Request for Waiver/Deviation

(14) Title of Waiver/Deviation: DTNPL FM Thermal Vacuum Test 온도 프로파일이 EV spec과 다소 상이한 부분이 있음				(15) <input checked="" type="checkbox"/> Minor <input type="checkbox"/> Major <input type="checkbox"/> Critical

1	(1) Project : DTN payload development		(2) MRB Log No. : MRB-DTNPL-014	(3) Date of Initiation : 2020.07.23.	
	(4) Spec. No. :	(5) Contract No. : N/A	(6) Quantity Affected : 1	(7) Total Lot Quantity : 1	(8) UER No. N/A
2	(9) Material Name : DTNPL	(10) Identification No. :	(11) Parts List : Base No. Indent with (10) : N/A	(12) Serial No. : 1012-KB-001F

Non-Conformance Report

■ DTNPL Thermal Vacuum Test 수행된 온도 프로파일 (Kelvin 단위)

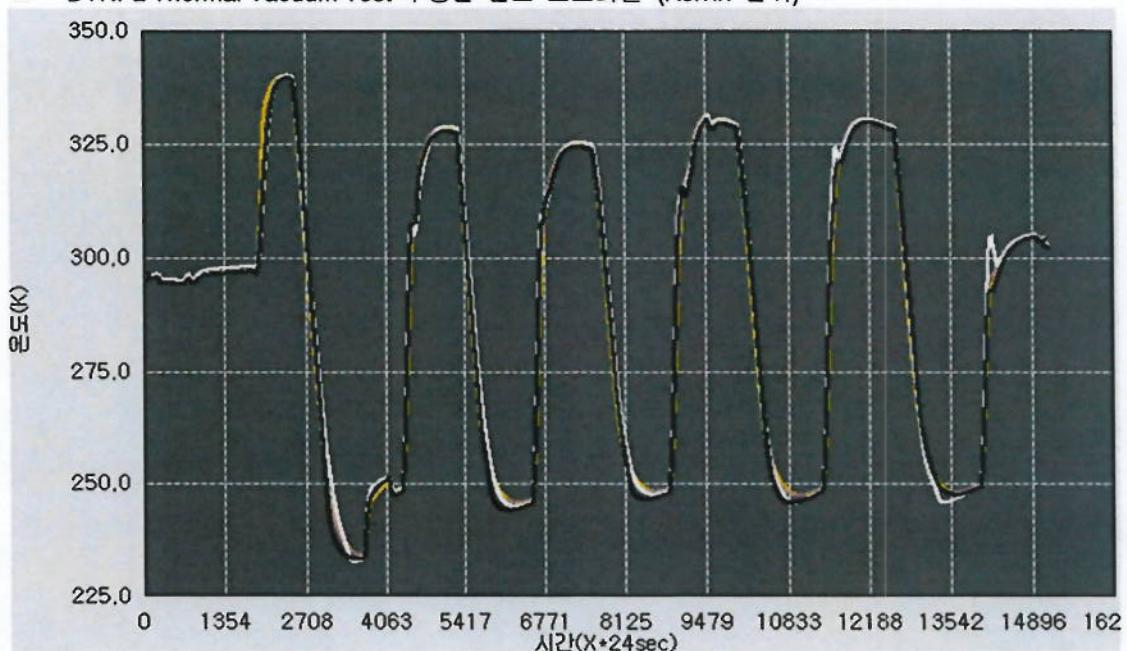
- KASI에서 진행한 DTNPL FM Thermal Vacuum Test 중 Chamber의 온도가 DTNPL의 EV spec과 다소 상이함을 확인
 - 1st Cold Soak 온도 (T_N)가 더 낮게 내려감 (DTNPL FM은 OFF 상태임)
 - S/B : -35°C
 - Was : -39°C
- DTNPL Thermal Vacuum Test Temperature Cycling EV spec

- Thermal Vacuum Test의 온도 프로파일이 DTNPL EV spec과 일부 상이한 부분이 있지만, Acceptance Test와 DTNPL의 기능에 영향이 없는 것으로 판단되어 Waiver 요청
- DTNPL에서 사용하는 부품의 온도 정보를 별도 제출 (부품의 Storage Temperature 재확인)

▪ TV Test Temperature Cycling

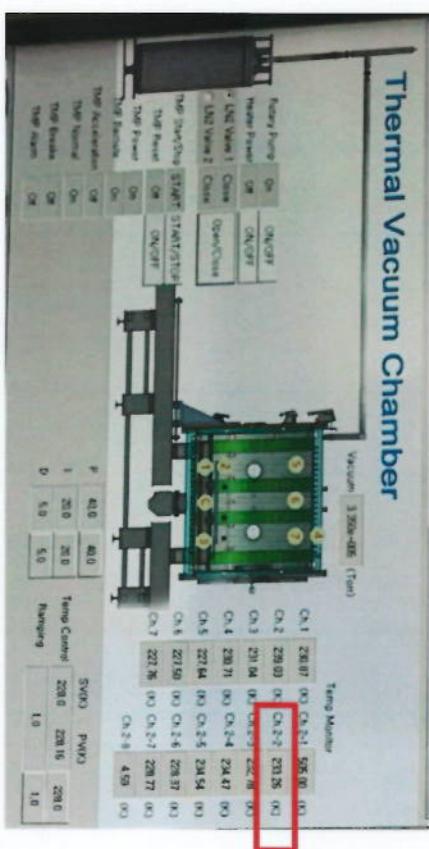
- 1st Cold Soak 온도 (T_N)가 EV Spec 대비 더 낮게 내려감
 - S/B : -35 °C
 - Was : -39 °C

- 2020.07.21 09:03 (이상현상 확인)
 - 1st Cold Soak 온도가 -35 °C 보다 더 낮은 온도인 **233.26K (-39°C)**까지 내려간 것을 르미르 Test Operator가 발견 및 KASI Chamber Operator에게 전달
 - 2020.07.21 09:47 (조치)
 - KASI Chamber Operator가 -35 °C로 올리도록 조치

- 해당 시험은 DTNPL이 OFF된 상태에서 기준 대비 4°C 더 Cold 충격을 주었으나 H/W에 문제가 생기지는 않았을 것으로 판단함
- 사용하는 부품의 Storage Temperate의 경우 마진이 많음 (별첨 참고)

- 열진공시험을 계속 진행하는 것으로 혐의함
- KASI Chamber Operator에게 주의를 줌

233.26K (-39 °C) 시의 Chamber 상황

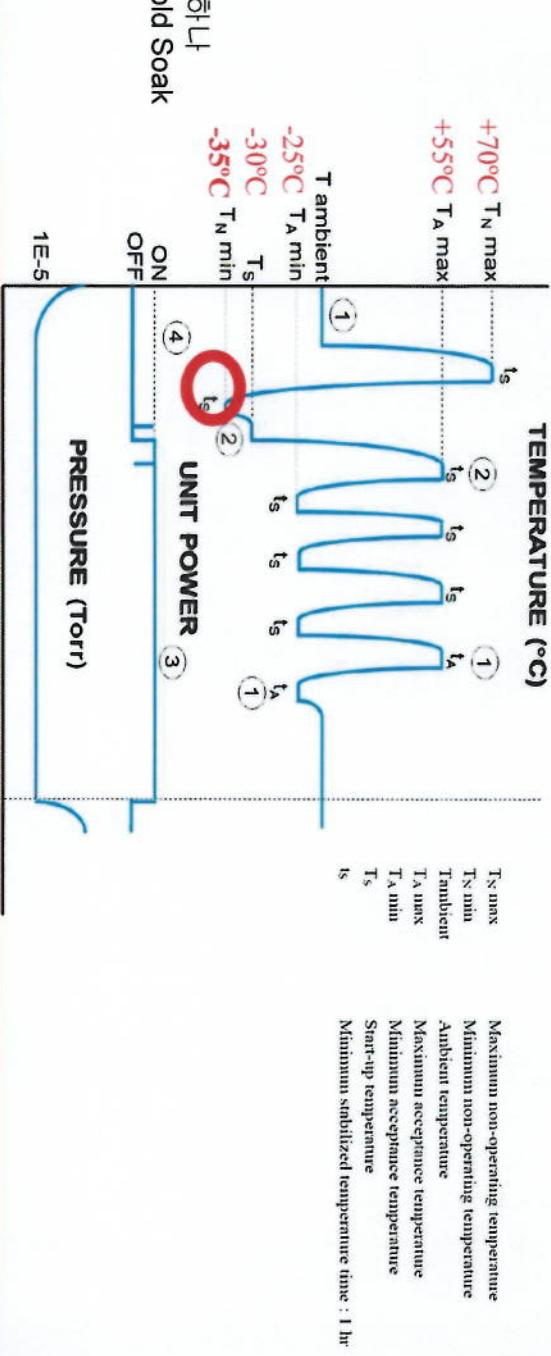
- KASI Chamber Operator의 챔버 Control 미흡
